Aqueous Solutions (owner) AQS-MFG-MEOH_FERM-GA_SIDE
MEOH_FERM fabrication drawing GA_SIDE (AQS-PLAN-006 M3; grap
Type: fabrication drawing (GA / nozzle orientation / part sheet) Rev e0f7418e Issued 2
Created: flow graph pipeline Approved: not approved (study)
Sheet 1 of 1 AQS-DWG-001

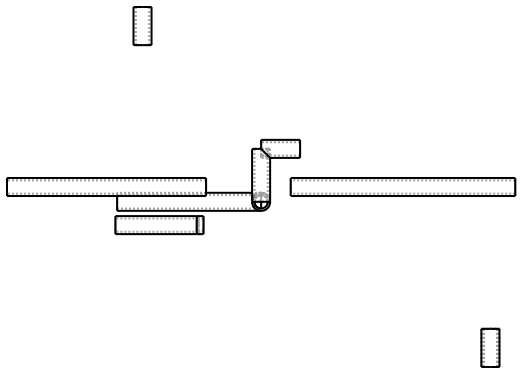
Graph revision AD - ga_side: Working level: the 48 h basis V = 0.0007 m3 (duty section 2) sets the level at z 297, reported from the model (A-VES); no new re
Graph revision AD - ga_side: Agitation is by the recirculation loop (the node mixer row): pump to the top head, return from the base; no top-entry agitator nam
Graph revision AD - ga_side: T 35 C per the node design sits inside the PVC-U class; above 60 C the thermoplastic
